**CITY OF WILSONVILLE
SECOND AMENDMENT TO CONSTRUCTION CONTRACT****5th Street/Kinsman Road Extension**

Exhibit A - Change Order #02
Pay Item Adjustment

Exhibit B – Change Order #02

SW 5TH ST TO SW KINSMAN RD EXTENSION
COFFEE LAKE CREEK (5TH ST) BRIDGE
PLAN AND ELEVATION

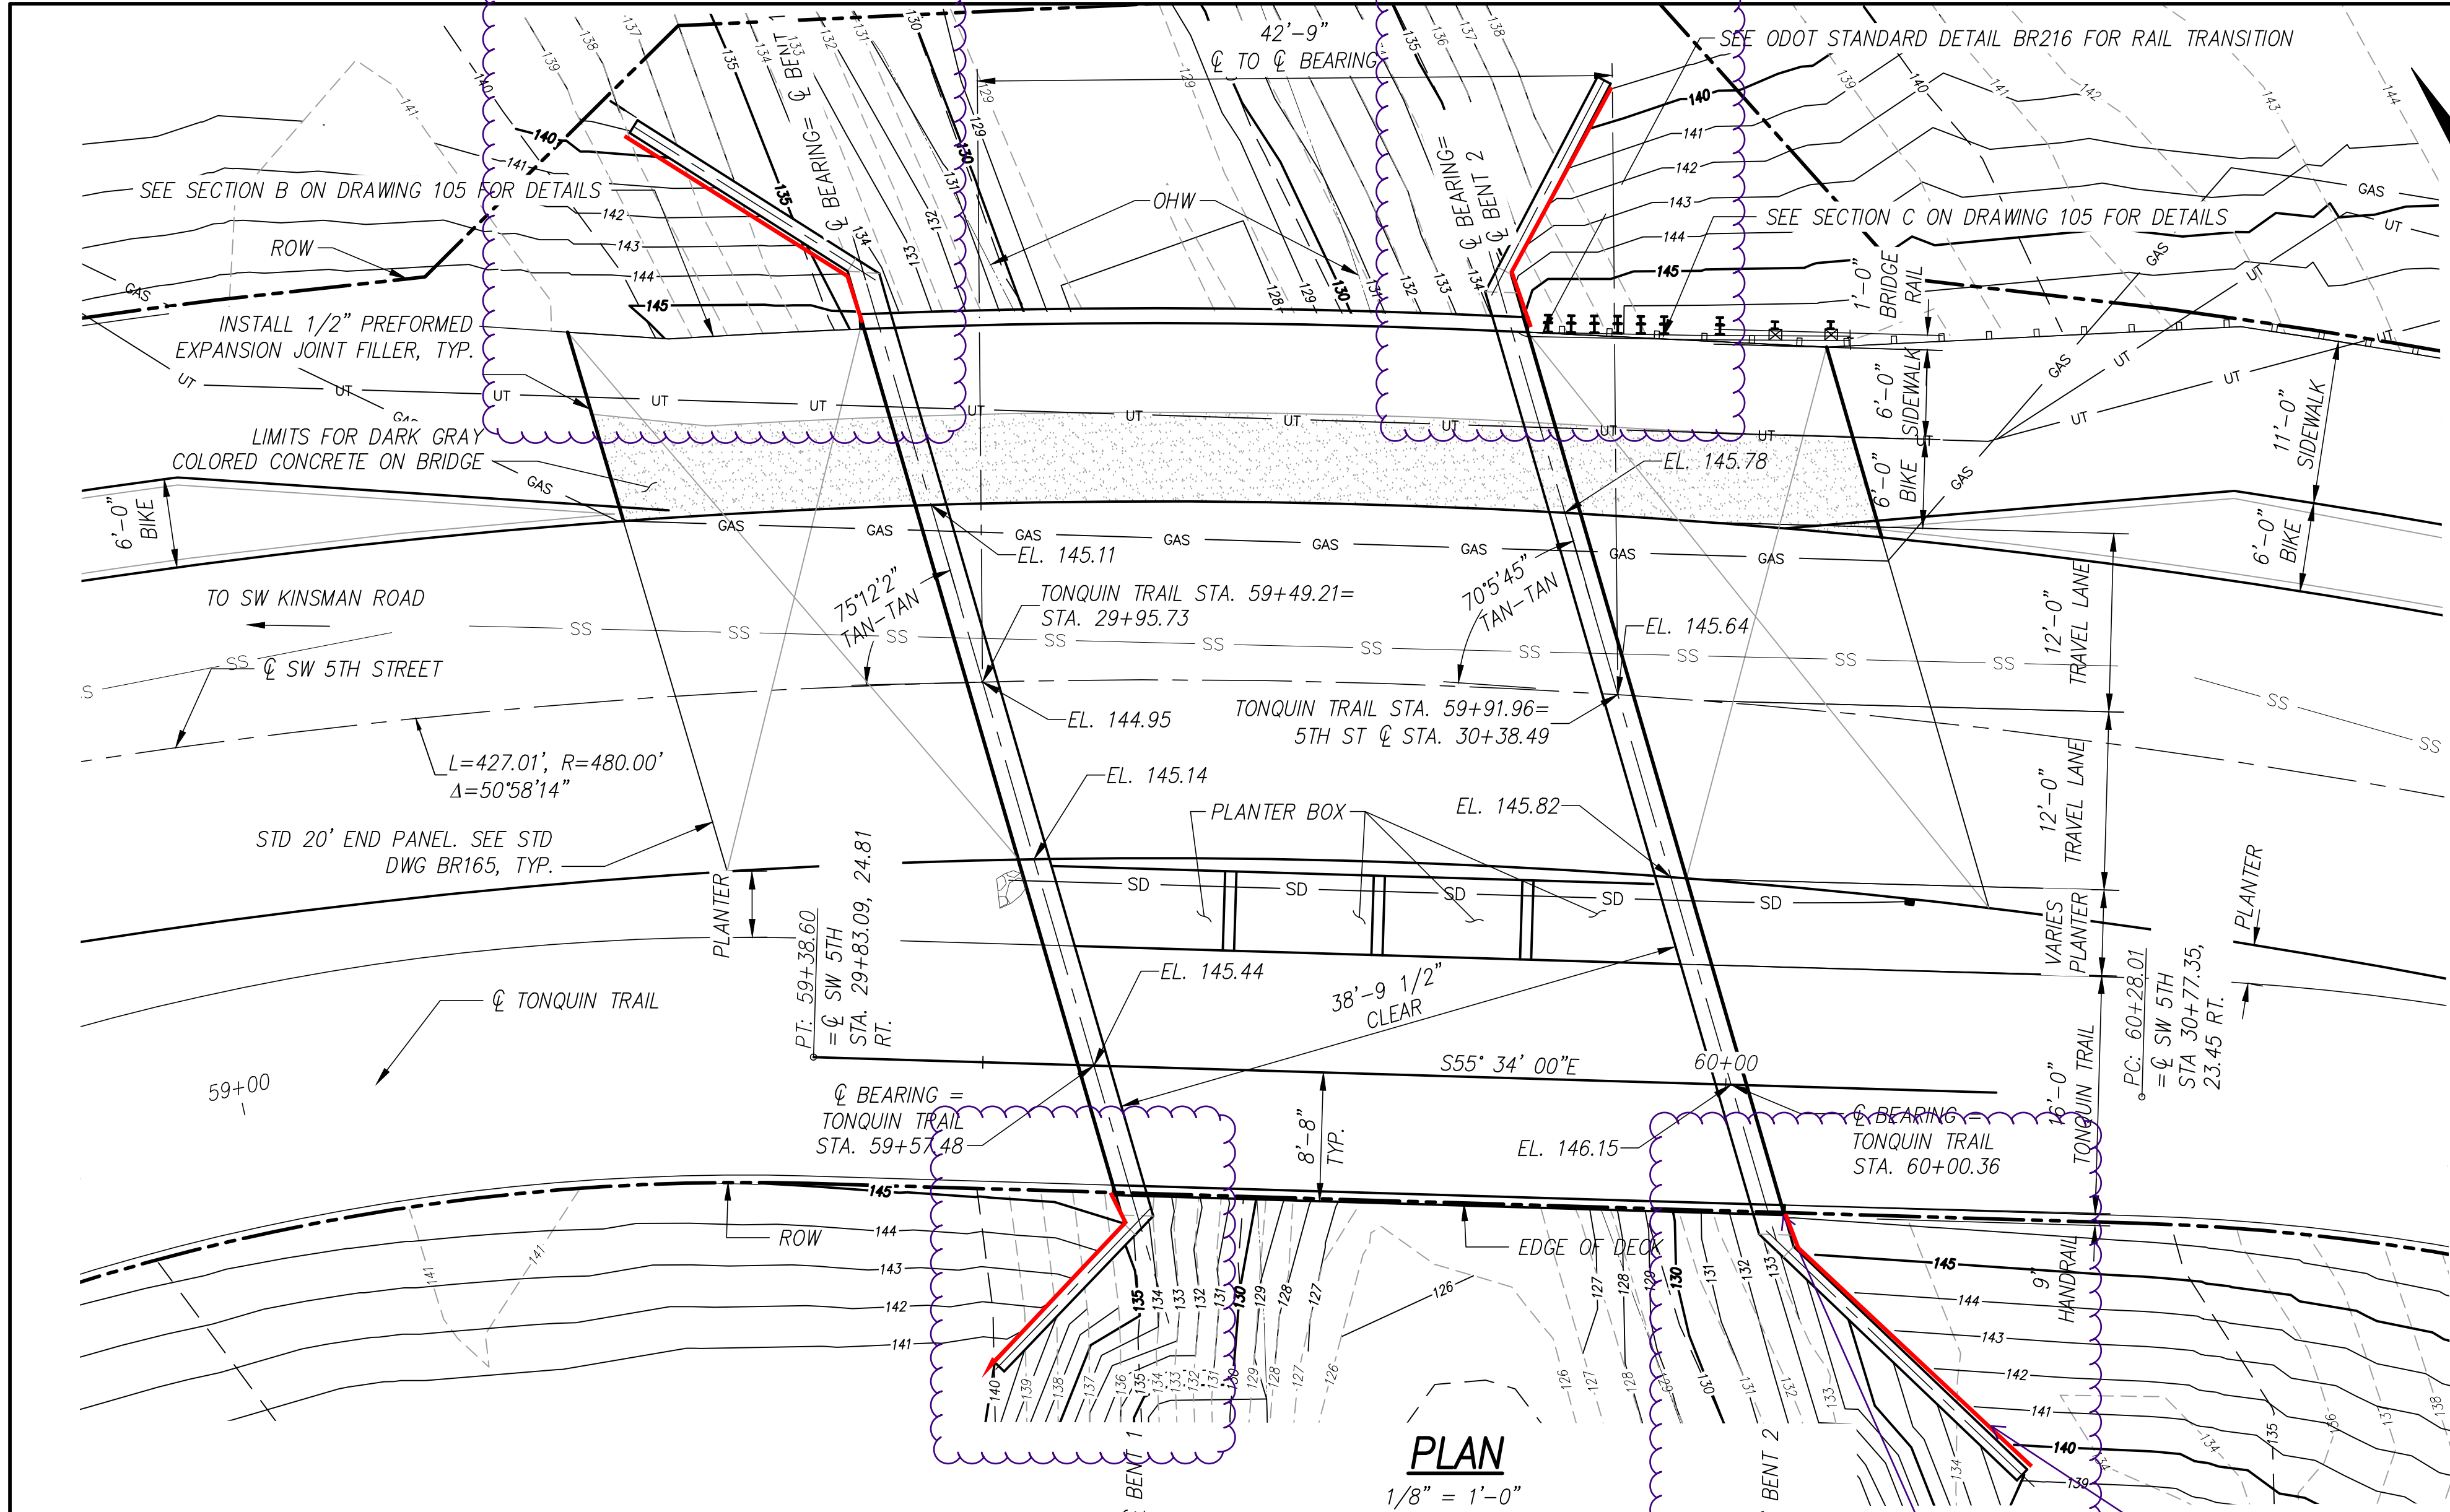
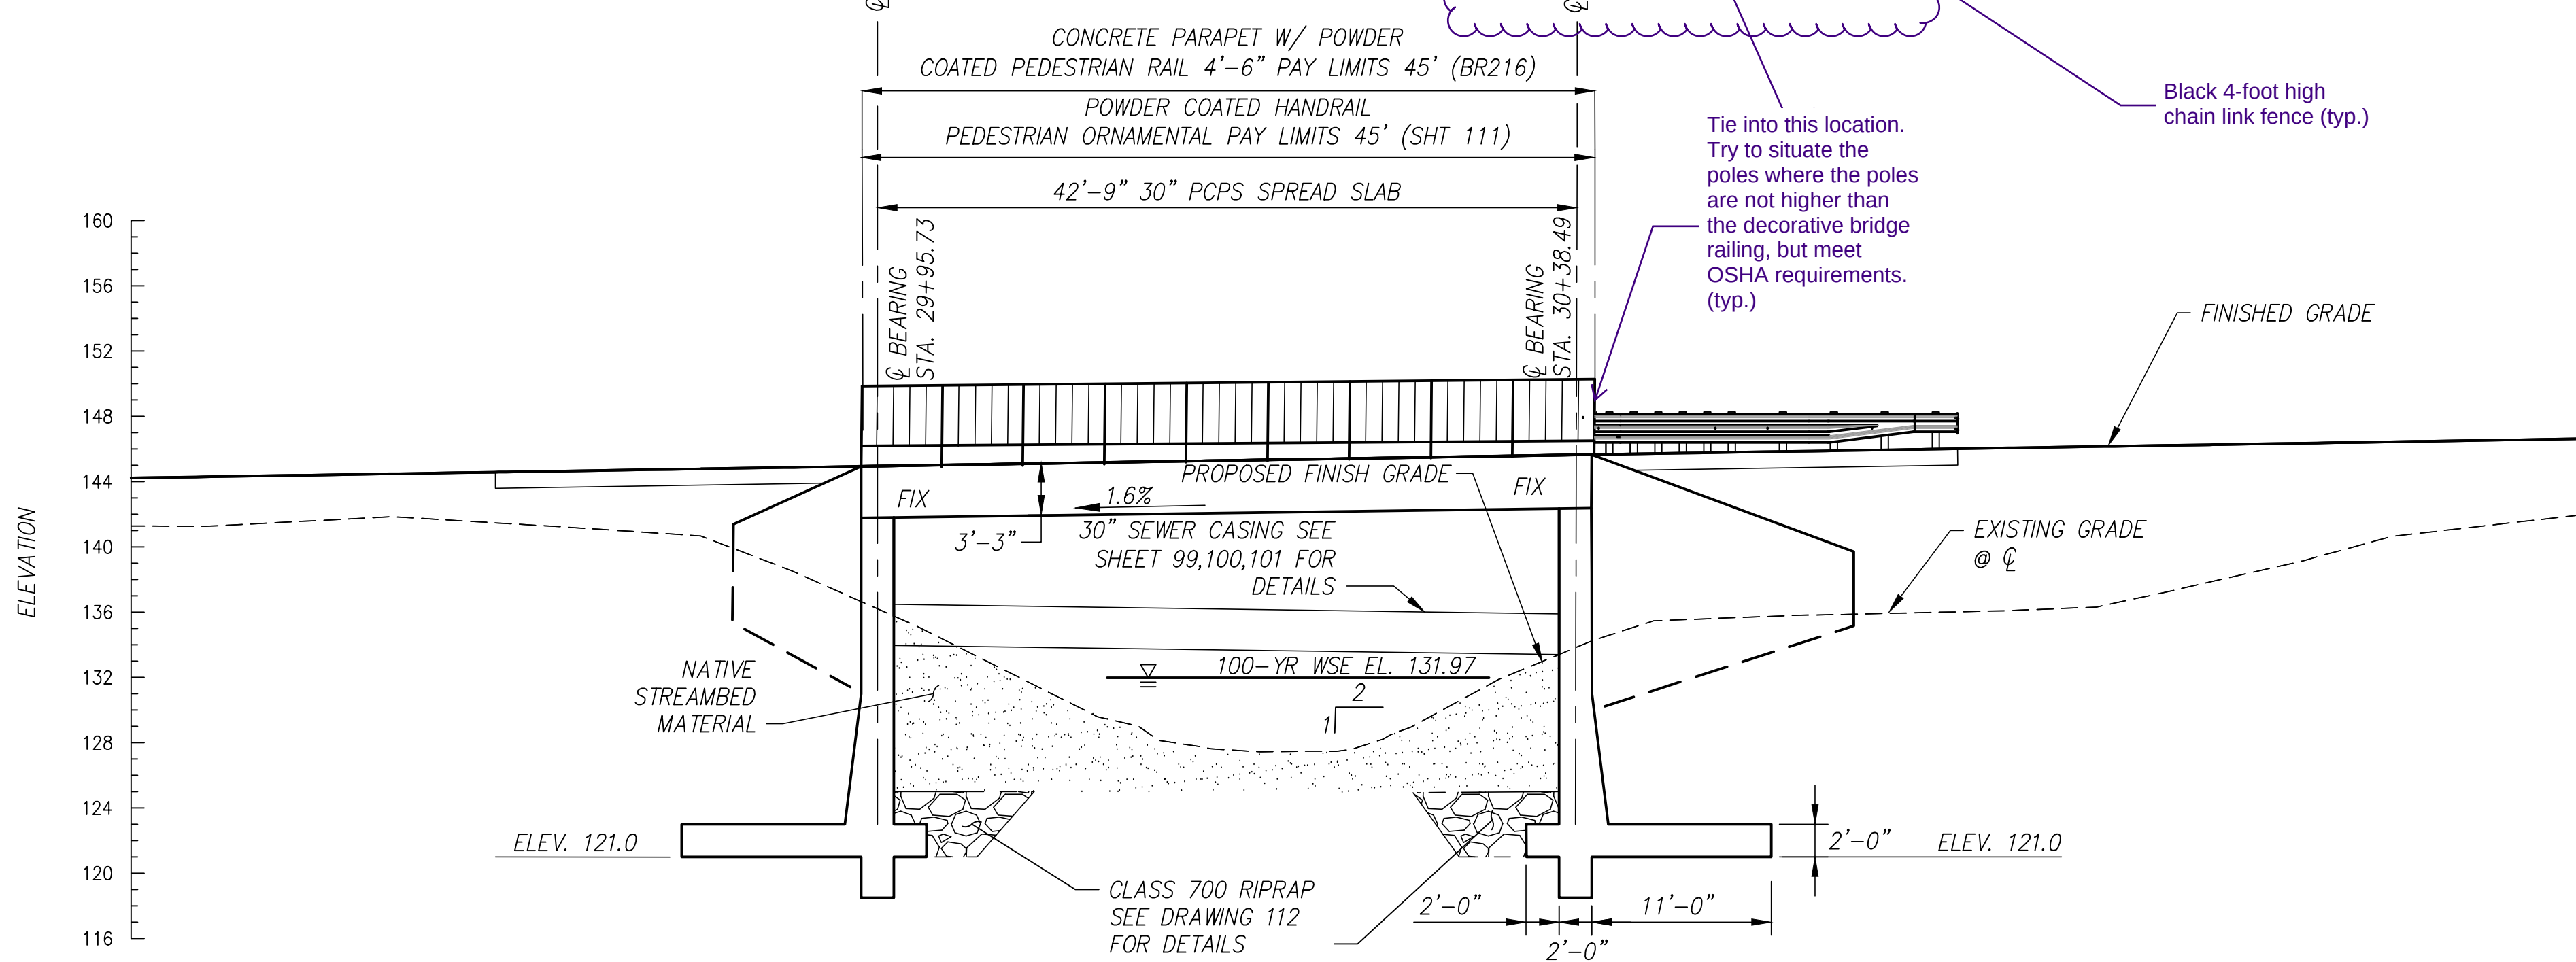
Contractor raised a safety concern with the design engineer regarding a potential fall hazard where the sidewalk is adjacent to the bridge wing wall. There is an elevation difference of up to 4 feet between the top of the bridge wing wall and the adjacent Coffee Lake Creek with no barrier provided between the sidewalk and bridge wing wall. The City and design engineer agreed with the Contractor's safety concern and proposes installation of a 4-foot high, black, vinyl coated, chain link fence for each wing wall on both the 5th Street Bridge and Kinsman Road Bridge as documented in RFI 080 (p. 29-32 of Exhibit C).

Sheet PP-03 Note 25 calls for a 31" height guard rail.

The city would like to add chain link fence. Please provide a proposal for installing 4-foot high black chain link fence (CWS standard detail No. 792) for each bridge. The fence locations would be from the corner for the bridge railing along the back side of the wing walls at all four corners. Please follow OSHA standards and requirements. The tops of the poles should be situated as best as possible below the decorative bridge deck railing. Confirm field location and fit with city inspector prior to placing.
